Master Development Drainage Plan &
Preliminary Drainage Report
Monument Ridge East
El Paso County, Colorado

SP241

August 5, 2024

◆ DRAINAGE PLAN
DEVELOPED CONDITIONS - OVERALL

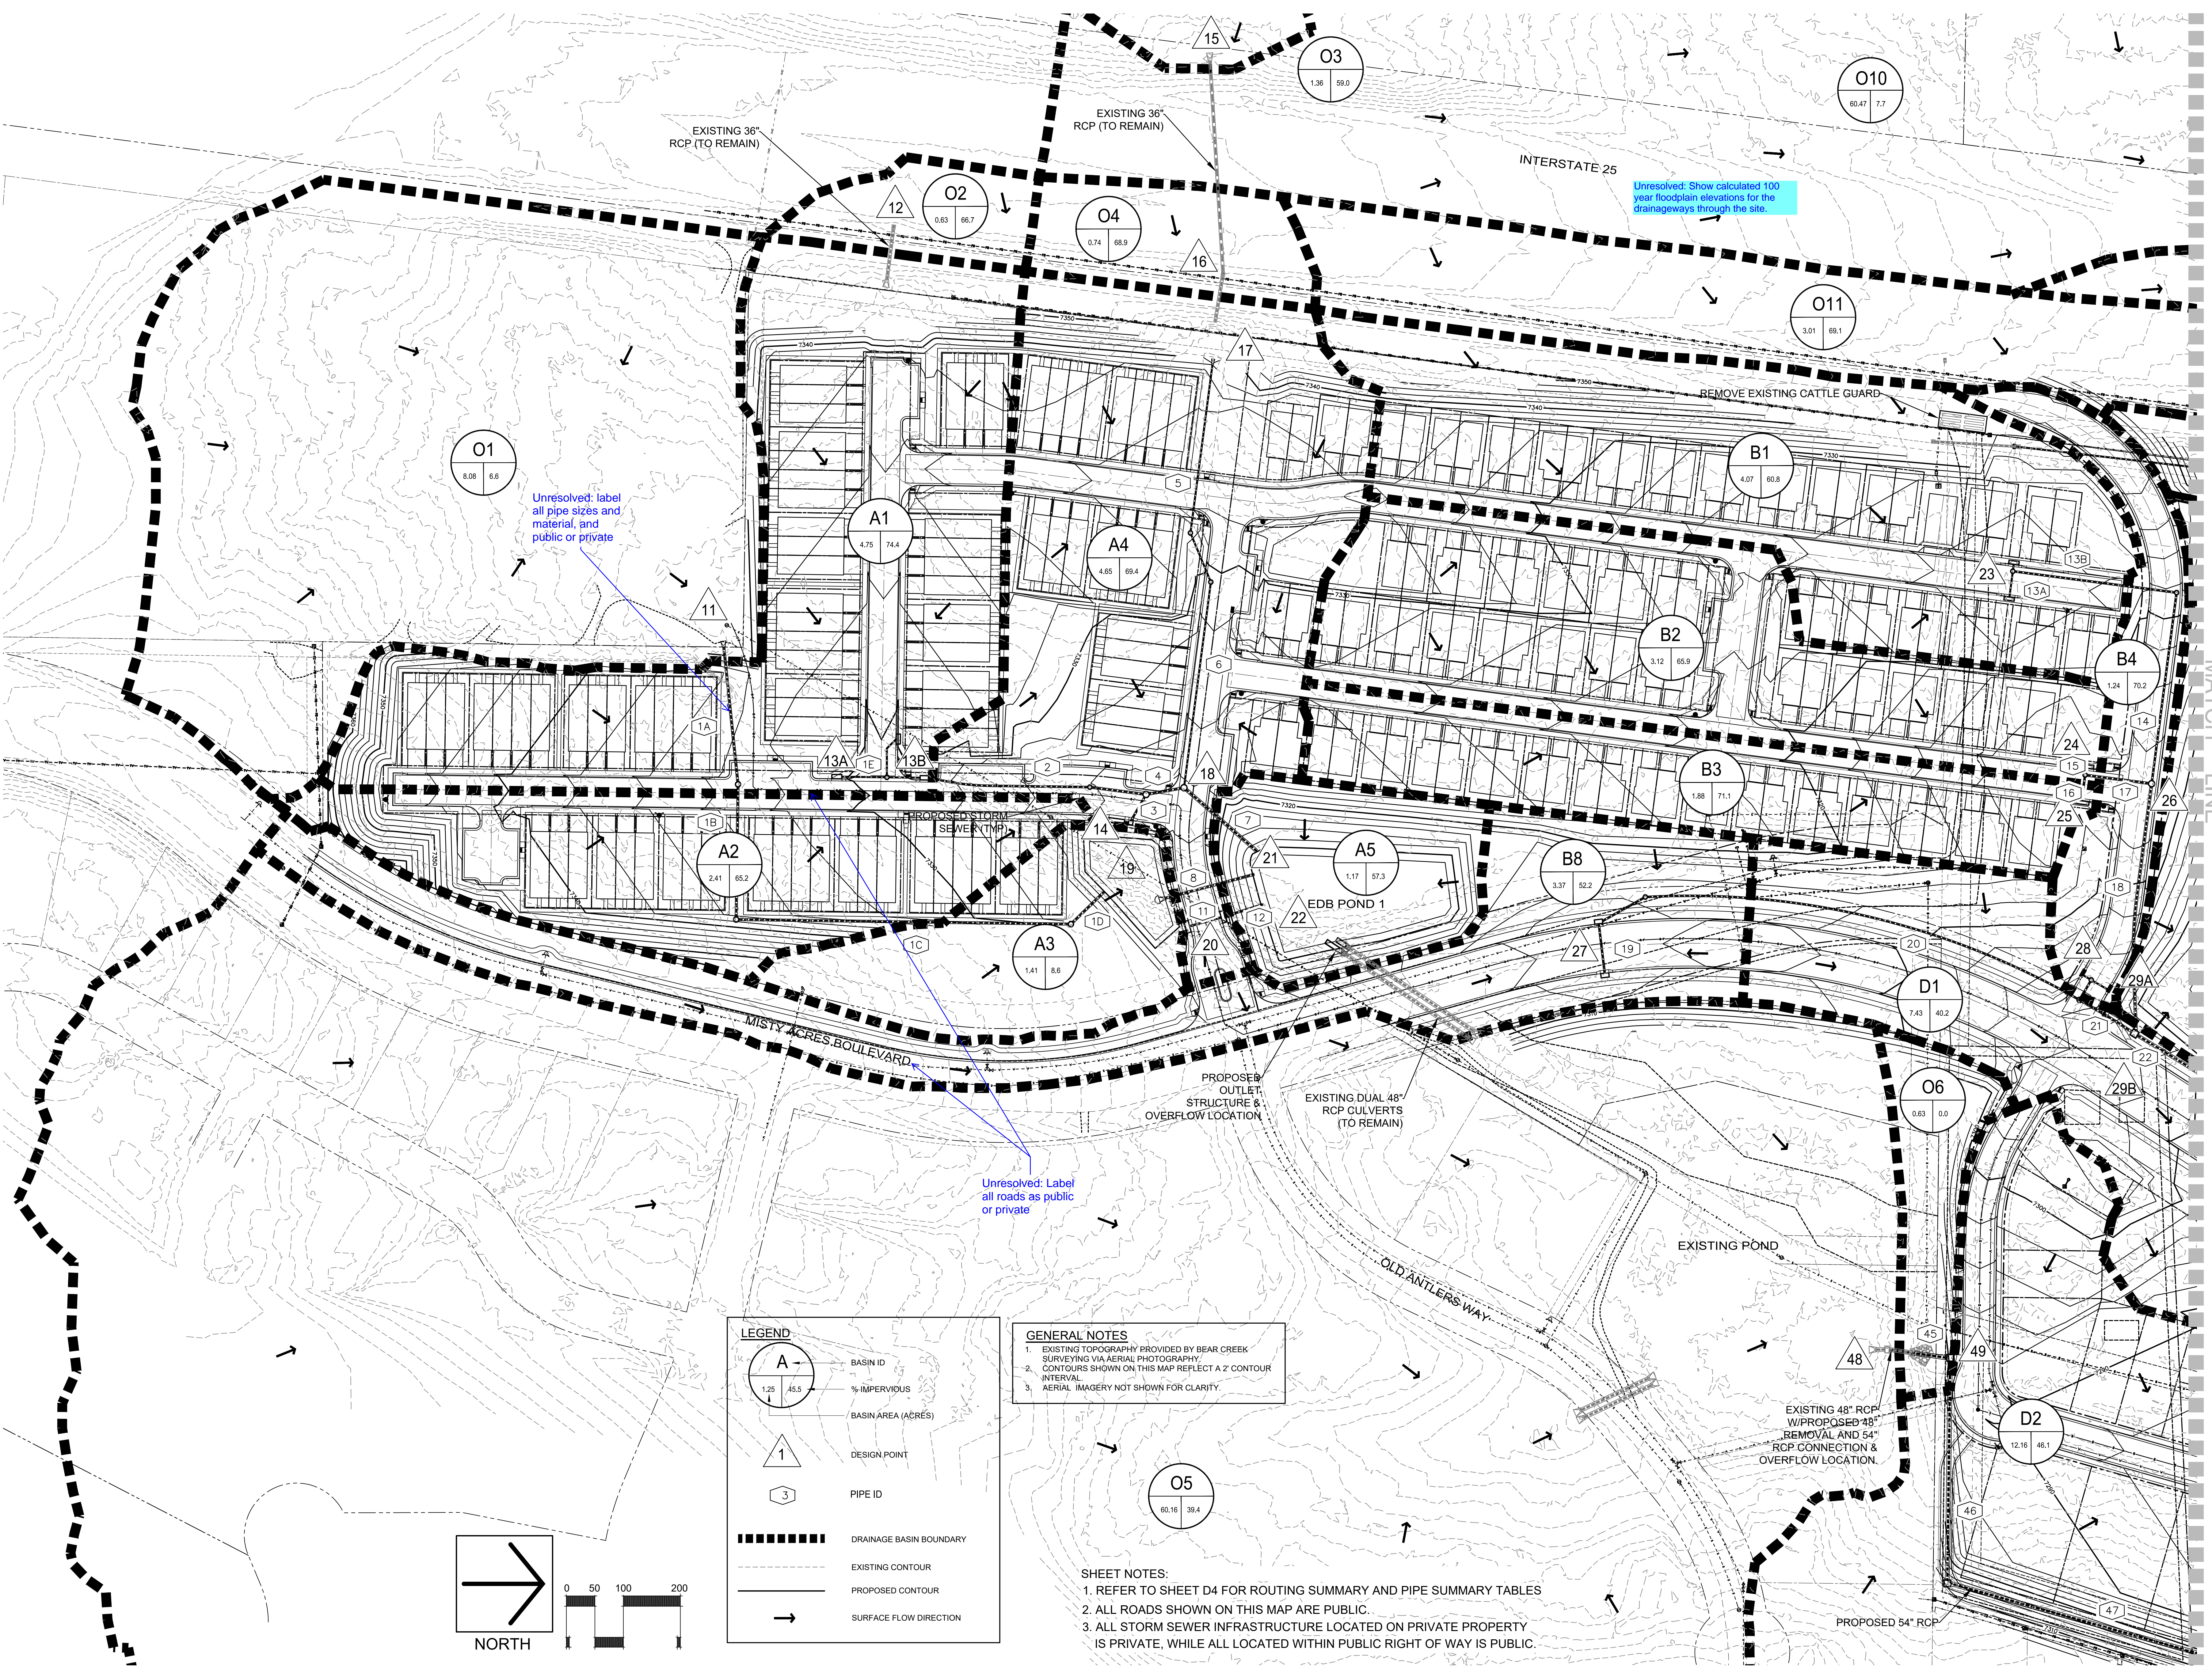
Unresolved: Show calculated 100 year floodplain elevations for the drainageways through the site.

DRAINAGE PLAN
 DEVELOPED CONDITIONS - NORTH

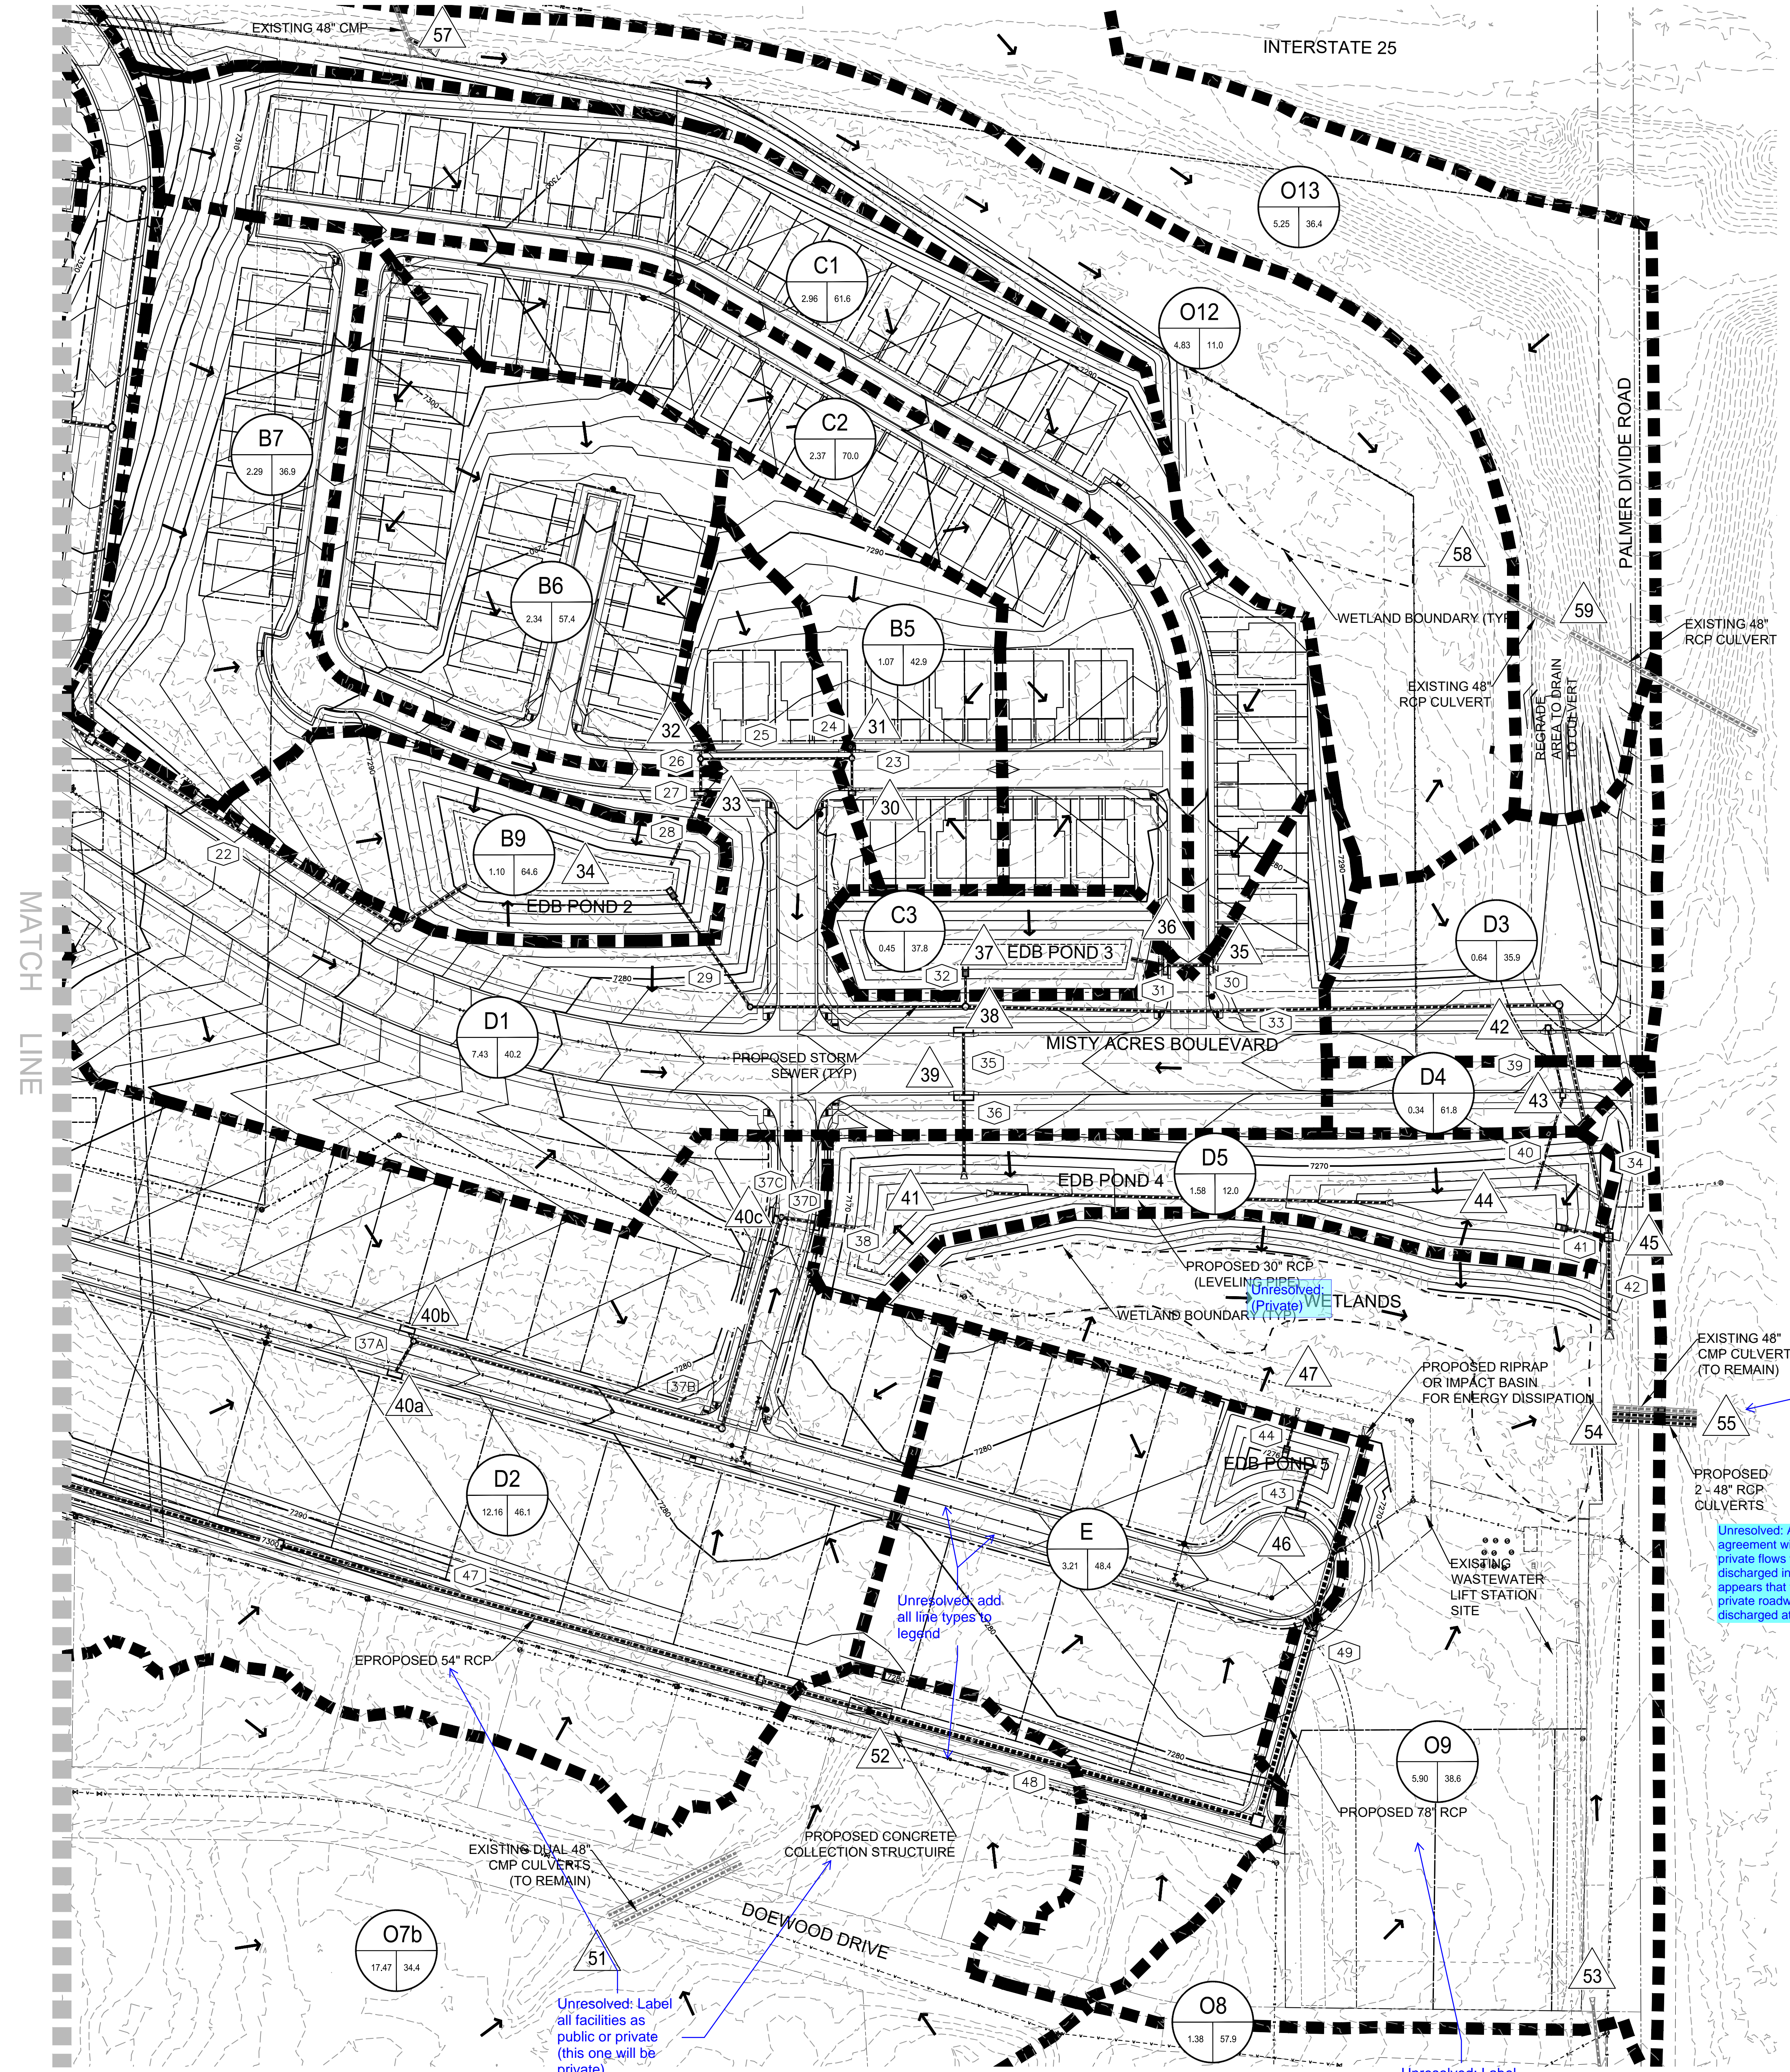
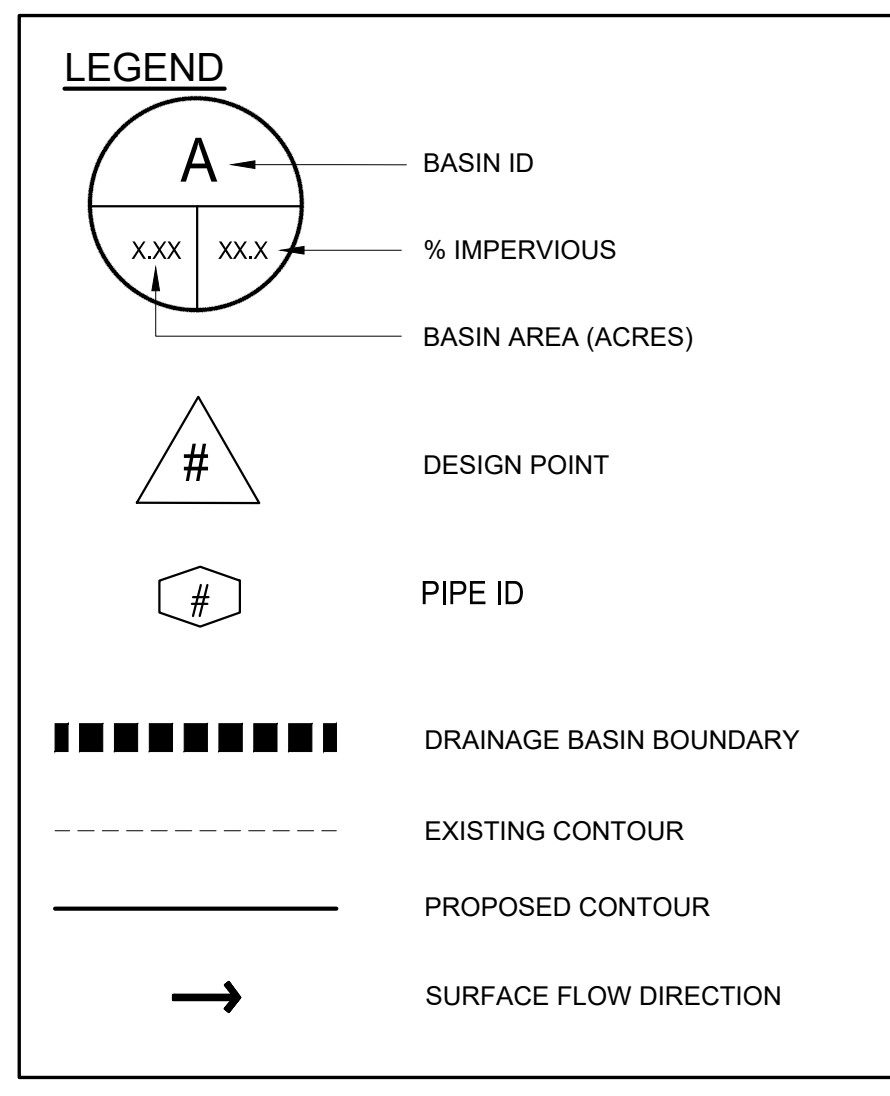
Unresolved: add a column for public/private

Unresolved: Address the downstream easements that will be needed for construction and additional conveyance
